Department of Transportation

MEMORANDUM

SUBJECT: ZC Case No. 20-27 – 7th and P Street NW

Figure 1 | Site Plan (Source: Gorove Slade 3/26/21 Transportation Statement, Figure 4)

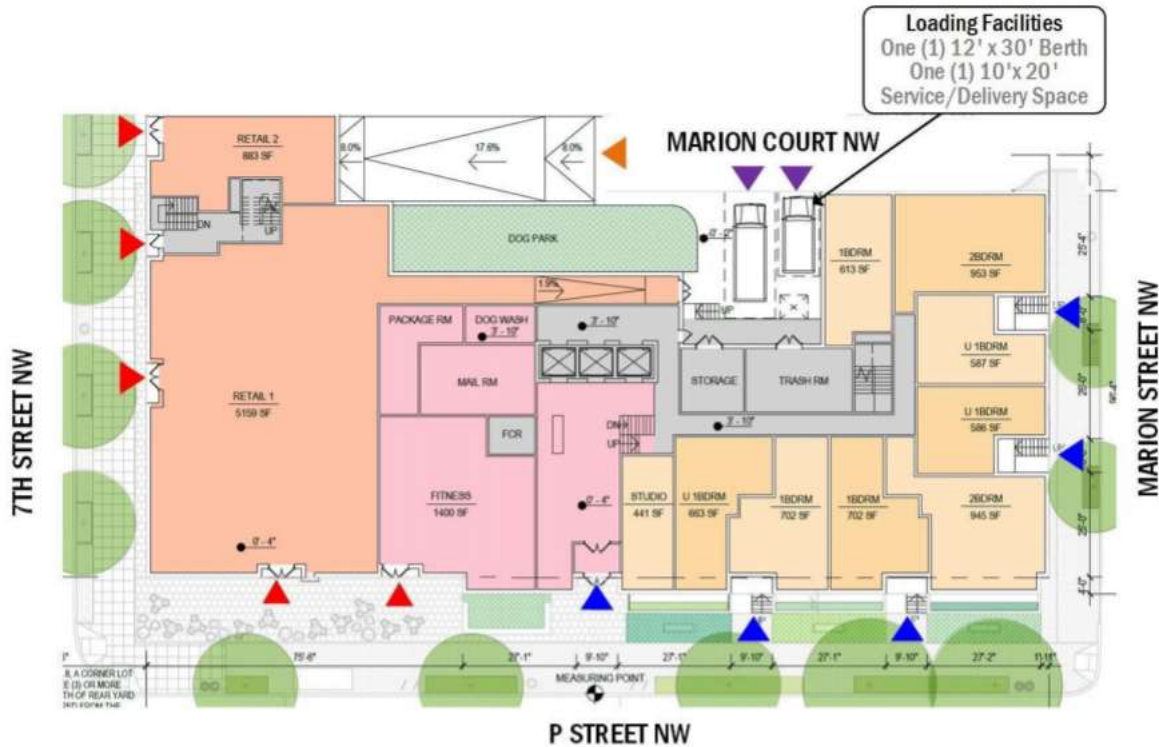
Vehicular access to the below-grade parking garage is proposed via a two-way entrance/exit from the 11.5-foot public alley within the existing alley network. The alley serving the rear of the site connect to Marion Street NW at two (2) locations. The loading dock area is also accessed via the public alley. The proposed access to both parking and loading meets DDOT's standard that all vehicular access be provided via the alley network when available.

The project proposes no new curb cuts to the public street network and instead will be closing the existing curb cut on P Street, consistent with DDOT standards for minimizing curb cuts. Figure 1 below shows the site layout of the proposed project.

- DDOT concurs that the existing curb cut on P Street NW should be closed and replaced with green space and street trees;
- Bay windows on P Street NW should not project more than 4-feet into public space;
- Lead walks should not exceed six (6) feet in width within public space; and
- Steps should not project more than 10 feet into public space from the property line.

Figure 4 | Existing Pedestrian Network (Source: Gorove Slade 3/26/21 Transportation Statement, Figure 5)

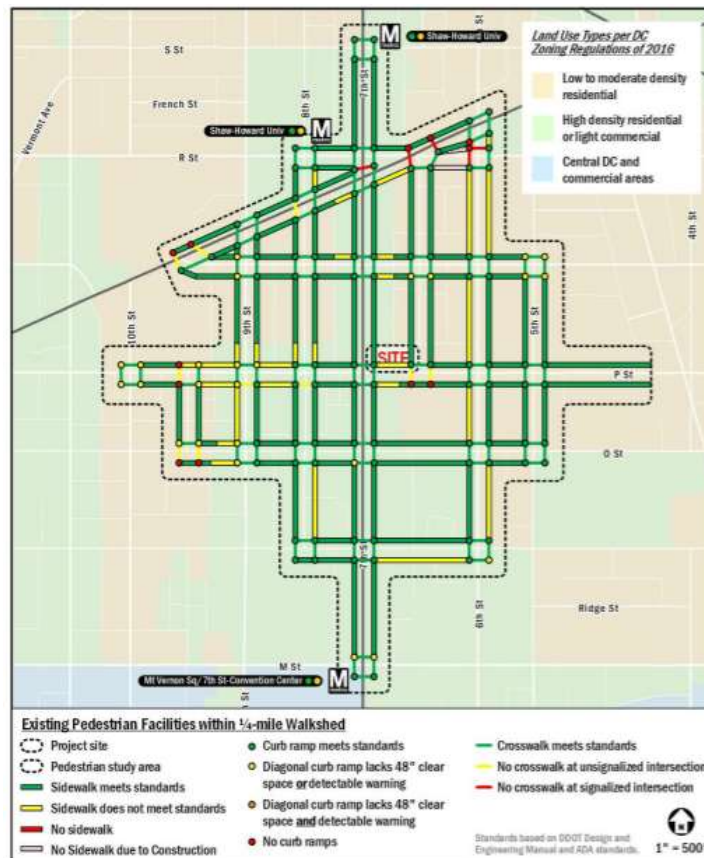
The Applicant’s inventory of existing pedestrian infrastructure, as shown in Figure 4 below, demonstrates that most sidewalks in the immediate vicinity of the site are currently constructed with appropriate widths and include accessible curb ramps. While there are a number of missing or substandard facilities in the broader area, the existing pedestrian network along major walking routes from the site to schools, attractions, and the Metrorail station is generally adequate.

Figure 5 | Existing Bicycle Facilities (Source: Grove Slade 3/26/21 Transportation Statement, Figure 6)

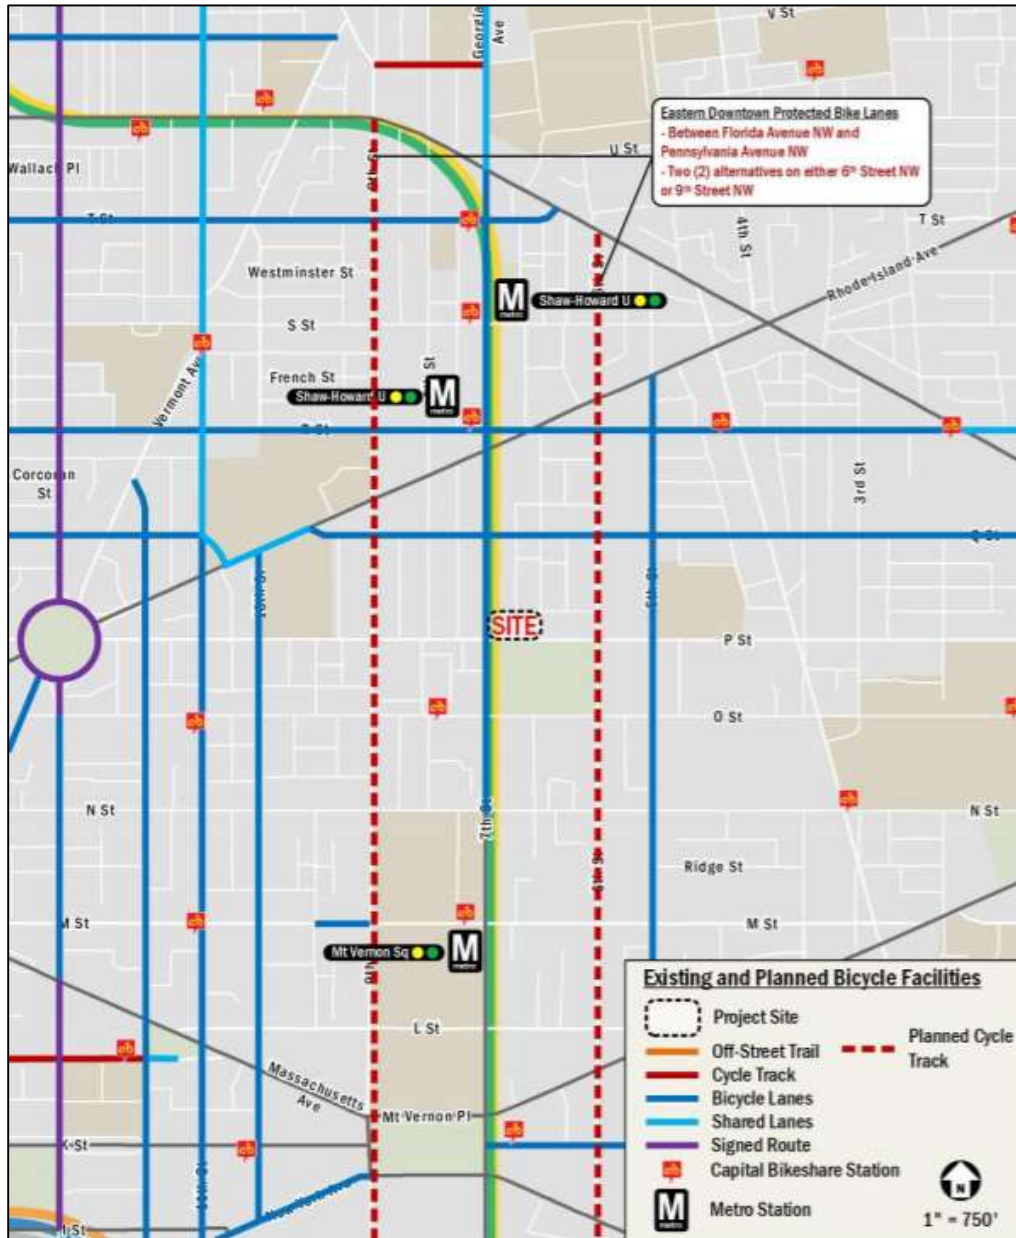
As shown below in Figure 5, there are five (5) Capital Bikeshare stations with a total of 52 bicycles located within a ¼-mile of the site. Bicycle lanes are also available nearby on 7th Street NW, Q Street NW, R Street NW, and 5th Street NW. These facilities connect to the Metropolitan Branch Trail to the east of the site. Additionally, one protected bike route is planned nearby on 6th Street or 9th Street NW.
